RANKING FORM BID 20/21-1-1 (Tab: 11)

AMCD is building a 6000 sq. ft., (60' X 100' foot print) single story building that will house an education center. This building will be located at 120 EOC Drive St. Augustine FL 32092 East of building 400 and south of the east parking lot. The design and construction of this project has been done in phases. Phase one was for the site plan, building plan and construction of the site work. The current bid, phase two, is for building construction to include erection of the steel building, the completion of the site work and construction of the interior including, but not limited to, walls, ceiling, flooring, counters, electric, plumbing, HVAC, data, phone, alarms, keycard and installation of displays. The education center will educate the public about disease vectors and vector borne diseases, especially mosquito borne diseases.

St. Johns County Fire Services had comments on the plans submitted.

This addendum is meant to clarify questions raised at the pre-bid meeting as well as address other important information.

SHEET G-1

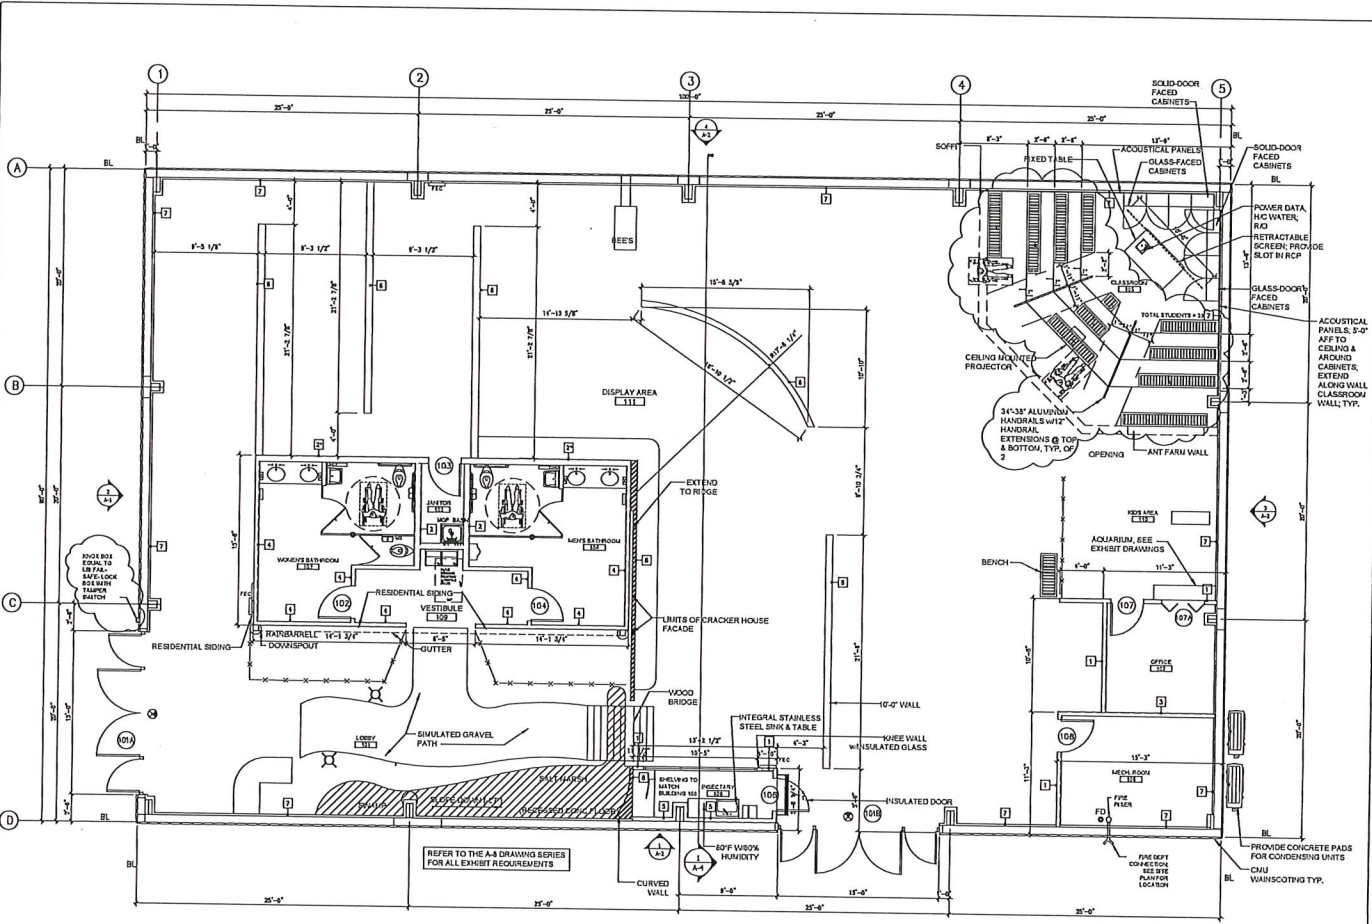
8) The fire alarm and sprinkler plans are conceptual and require a separate fire permit.

Acknowledge on the plans that the fire alarm and sprinkler plans will be deferred submittal.

Response: See sheet G-1 for notes requiring the additional permits for fire alarm, fire sprinkler system and the photovoltaic system.

A-1

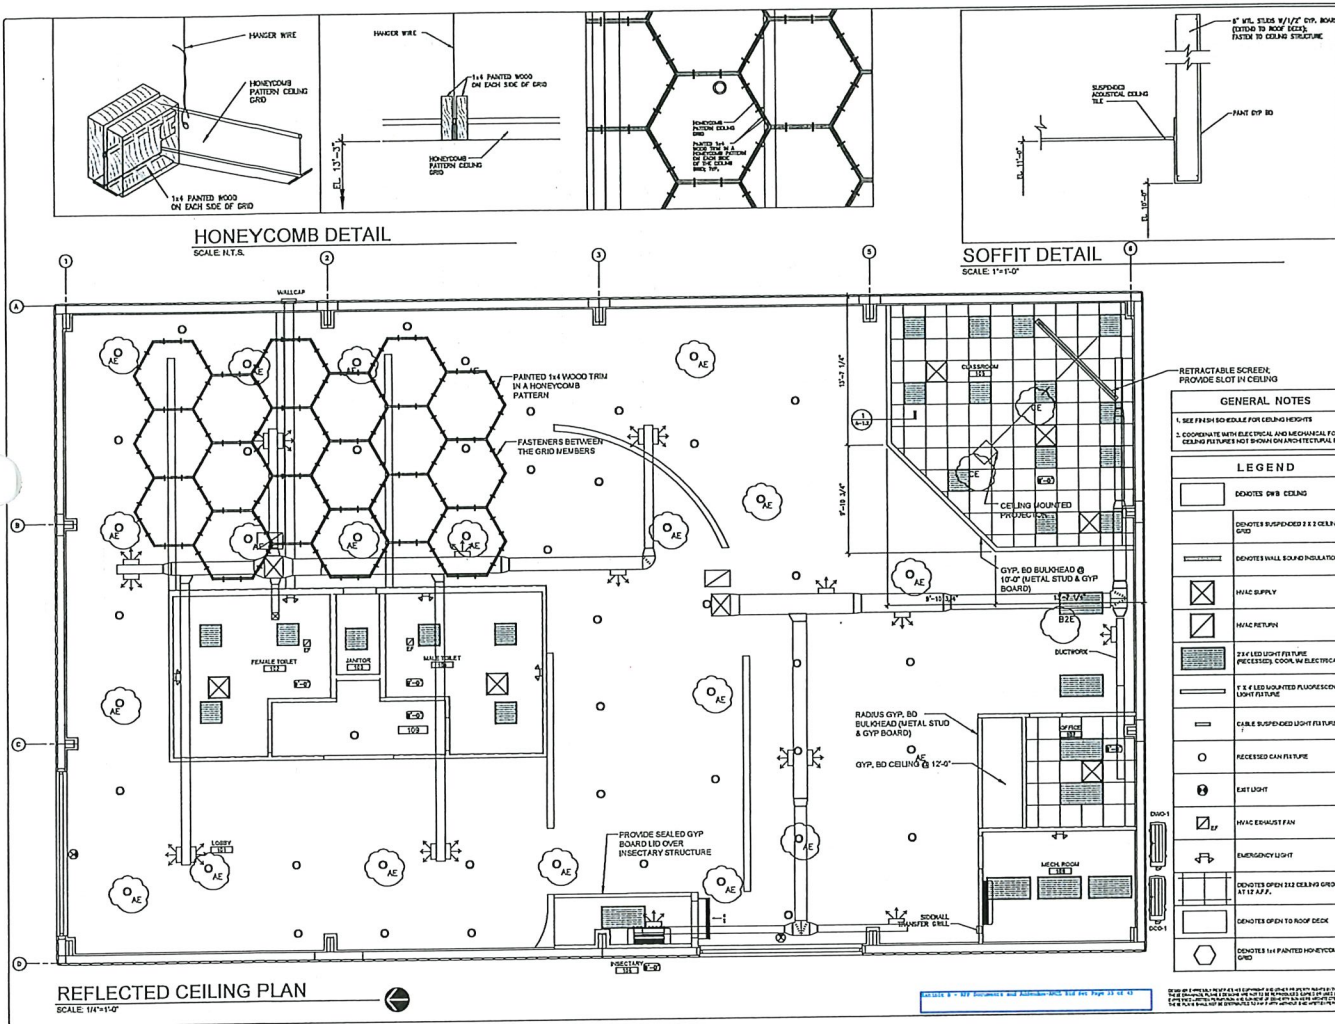
6) Classroom 105 (theater seating) Does not show handrails down the center of the two isles. The isles do not provide the minimum 23 inches clearance on both sides of the location where the handrails will be placed. 101:12.2.5.6.3(3).

Provide an exhibit showing the handrails, for review.

Response: See sheet G-1, A-1 & A-8.6 for the handrail additions/revisions. Seating has been reduced to 39 seats. 23" clearance has been noted on each side of the handrails.

Response: See sheets G-1 & A-1 for notes on the required Knox-box.

E-2

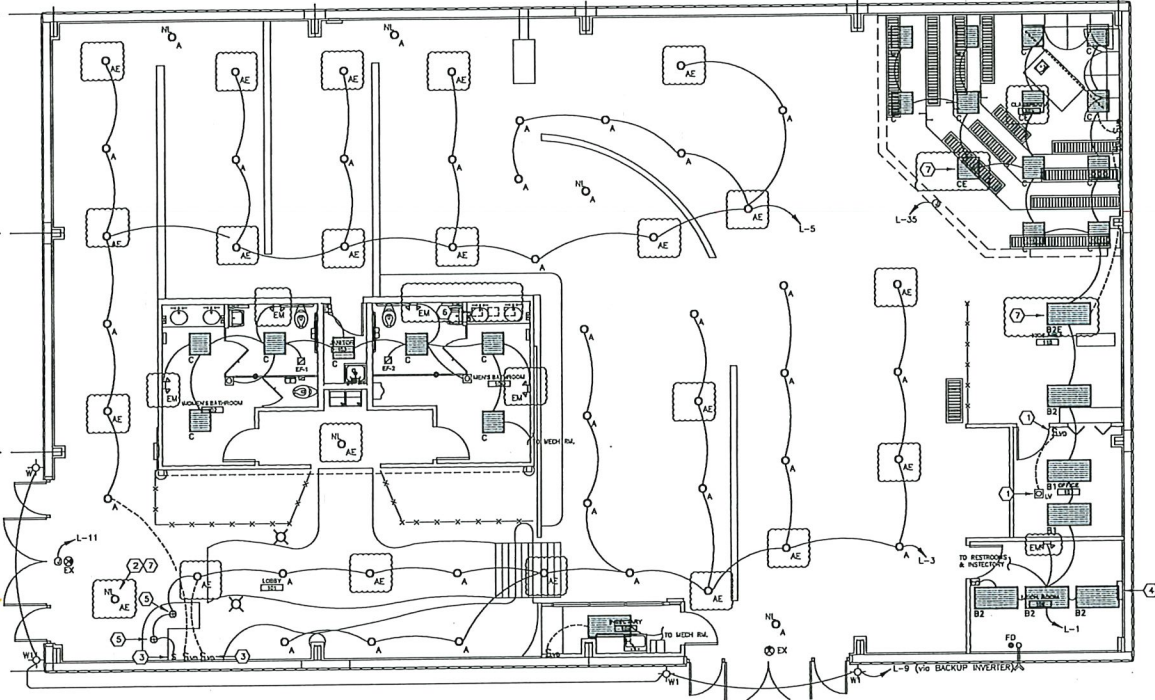
2) Sheet C-1 identifies a fence encompassing exit door 101B blocking egress to a public way. Sheet E-2 identifies a pedestal mounted security push button for emergency gate exit. No door number, hardware group information provide.

Provide egress lighting to and at the gate and emergency lighting outside of exit doors 101A, 101B and at the gate.

Response: See sheet E- 2 for emergency lighting at the gate.

E-3

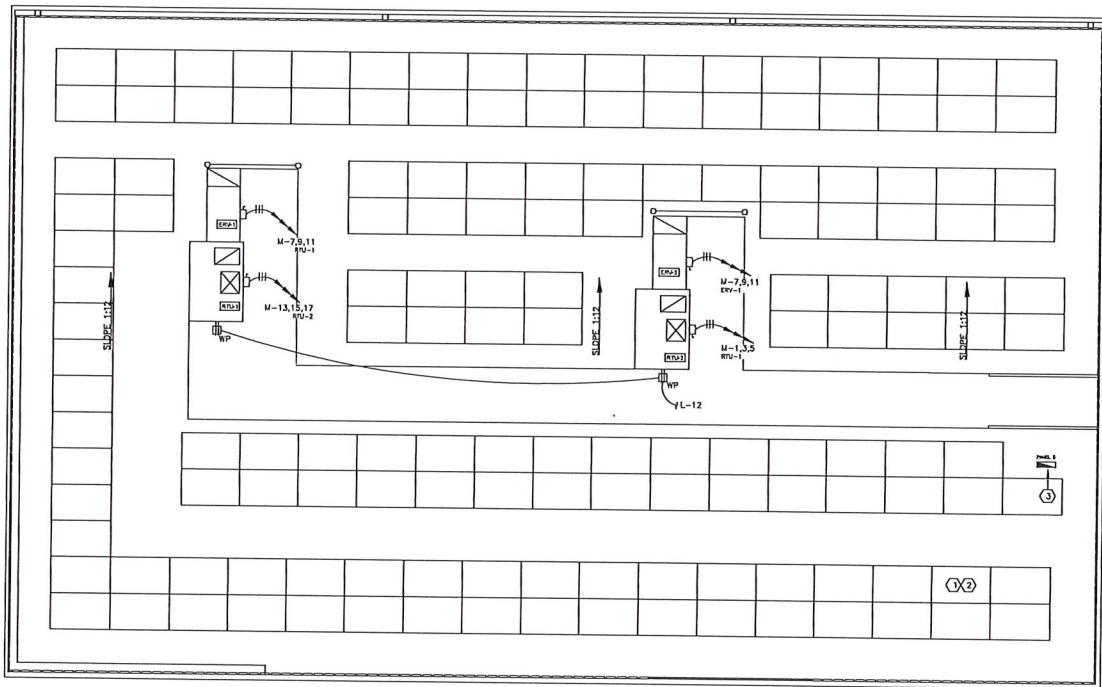
4) Emergency Lighting. The emergency lighting shown on electrical sheet E-3 consists of wall mounted fixtures (wall-packs). Wall packs are typically used for corridors and are designed to provide lighting in a specific width and length. The wall packs indicated in the plans (sheet E-8)

provide at best a 6 foot wide path with the wall packs installed 16 feet apart on center at a height of 8 feet. An individual wall pack would provide 6 feet wide by 8 feet long path.

The emergency lighting provided, with the exception of the bathrooms, does not appear to provide adequate emergency egress lighting throughout the facility. 101:12.2.9

- a) Provide additional emergency lighting throughout the facility to cover the egress paths including but not limited to the open areas, serpentine wall displays, lobby 101, classroom 105 (theater seating), kids area to open area, both side of the 10' wall by exit door 101, OR,
- b) Provide a photometric plan to show that the emergency lighting meets 101:7.9.2.1.1 from all areas of the facility.

Provide the circuits the emergency lighting is on so I can verify coverage.

Response: See sheet E- 3 for egress lighting to the gate and emergency lighting outside of exit doors 101A, 101B.

Response: See sheet A-1.3 and sheet E-3 for new emergency lighting layout and notes.

Response: See sheet E-3 for new emergency lighting to be on same circuit as the lighting.

A-2

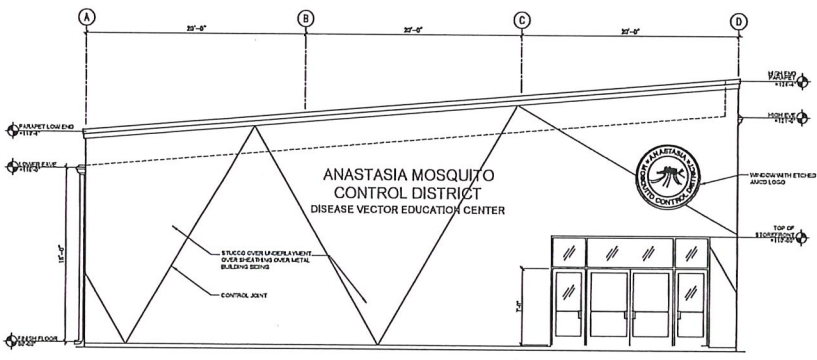
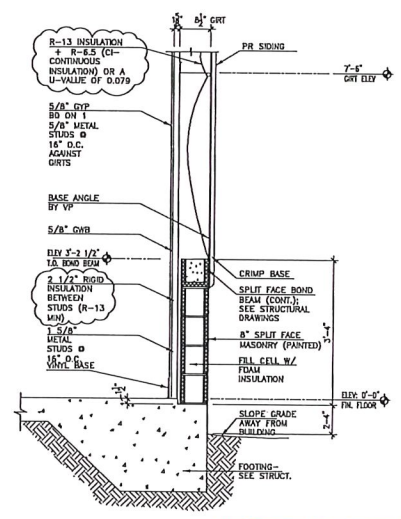
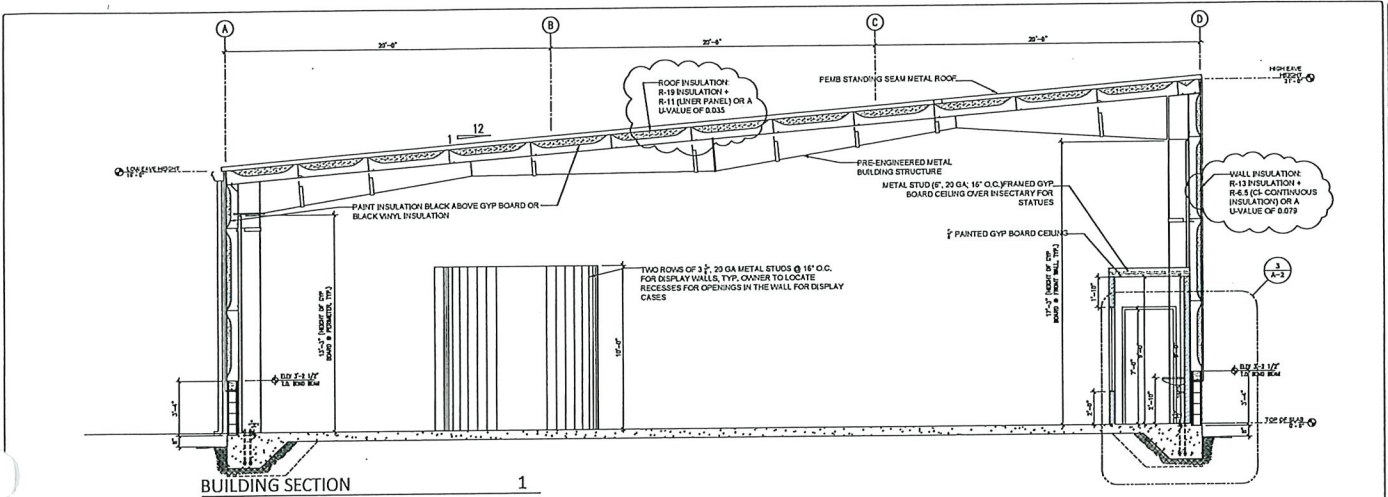
- Question: The only place I could find, stating the metal building insulation, was on A-2 and it stated the wall insulation was R-13, R-13 does not meet FL energy code.

- Answer: Roof insulation shall be R-19 & R-11 liner system or a U value of 0.035. The wall insulation shall be R-13 & R-6.5 continuous insulation or a U value of 0.079. Revised drawings with corrected insulation values pages A-2 and A-4 are part of this addendum, see Addendum 2-B.
